Project	IEEE 802.16 Broadband Wireless Access Working Group < http://ieee802.org/16 >
Title	Topology Acquisition for Optimized Handover in IEEE 802.16m
Date Submitted	2009-03-02
Source(s)	Xiangying Yang xiangying.yang@intel.com Muthaiah Venkatachalam Sassan Ahmadi Intel Corporation
Re:	IEEE 802.16m-09/0012: Call for Contributions on Project 802.16m Amendment Working Document (AWD) Content
Abstract	This contribution proposes text for the handover section of the 802.16m amendment document
Purpose	For discussion and adoption by TGm
Notice	<i>This document does not represent the agreed views of the IEEE 802.16 Working Group or any of its subgroups. It represents only the views of the participants listed in the "Source(s)" field above. It is offered as a basis for discussion. It is not binding on the contributor(s), who reserve(s) the right to add, amend or withdraw material contained herein.</i>
Release	The contributor grants a free, irrevocable license to the IEEE to incorporate material contained in this contribution, and any modifications thereof, in the creation of an IEEE Standards publication; to copyright in the IEEE's name any IEEE Standards publication even though it may inclu

Figure 16 A general call flow for seamless HO

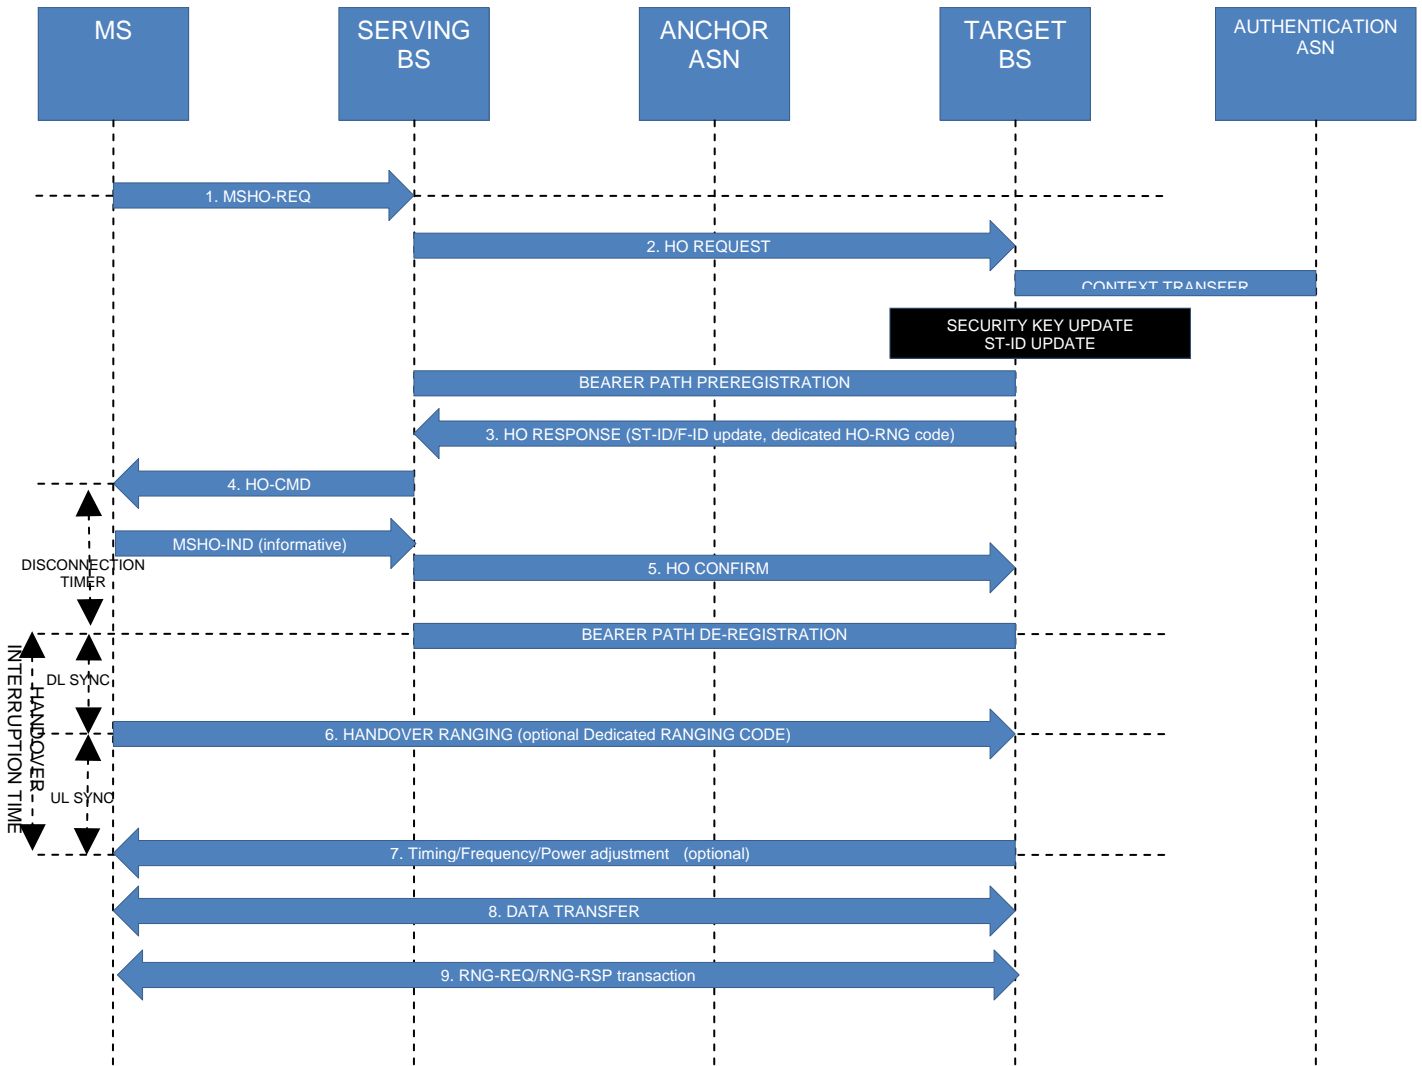
With proper network topology acquisition, an optimized HO call flow is shown in Figure 16. The network operation is informative. Some of the following steps may be optional.

1. The AMS initiates a HO by sending an HO initiation MSHO-REQ message to the serving ABS (S-ABS).
2. [NWG] S-ABS sends HO REQUEST to one or more target BS (T-ABS)

3. [NWG] T-ABSs reply S-ABS with HO RESPONSE, which may include HO optimization related MAC pre-update information.
4. In case of MS-initiated HO, the S-ABS responds to the HO initiation message by sending an HO command BSHO-CMD message to the AMS. In case of BS-initiated HO, the S-ABS sends an unsolicited HO Command BSHO-CMD message to the AMS without Step-1. In both cases (HO initiated by AMS or S-ABS) the HO command message shall include one or more target ABSs (T-ABSs).
If the HO-CMD message includes only one target ABS, the AMS should execute the HO as directed by the ABS. If the AMS is unable to maintain communication with the S-ABS until the expiration of disconnect time (defined in section 10.3.2.2.2), it may send a HO indication message to the S-ABS before the expiration of disconnect time. The S-ABS stops sending DL data and providing UL allocations to the MS after expiration of the disconnect time or after reception of HO-IND.

5. [NWG] Upon the disconnect time, the S-ABS sends HO CONFIRMATION to the T-ABS and may trigger subsequent data path switching.
6. Starting from the defined action time, MS performs HO ranging at T-ABS in dedicated opportunity or earliest ranging channel allocation by sending a HO ranging code in T-ABS's ranging channel for unsynchronized users.

7. Upon successful reception of HO ranging code, if uplink synchronization is required, T-ABS signal the MS to adjust its timing/frequency/power to achieve uplink synchronization.

8. T-ABS and MS continue data communication.
9. T-ABS and MS perform additional RNG-RSP/REQ transactions before the predefined timer, which also serves the purpose of mutual authentication between ABS and AMS.

AMS may skip step 5 and 6 when the network determines the AMS's synchronization with T-ABS is sufficient and CDMA ranging and synchronization will be omitted.

AMS may also maintain communication with serving ABS while performing network re-entry at target ABS as directed by serving ABS. Such capability is negotiated between MS and S-ABS and S-ABS assigns the DISCONNECTION TIMER sufficient for MS's network re-entry at T-ABS. In this case, Step-5 happens after Step 6 and 7.

In the optimized handover case shown in Figure 16, the service interruption time during handover starts from disconnection time (step-5); ends at either the completion of synchronization or data path switching, whichever comes last.
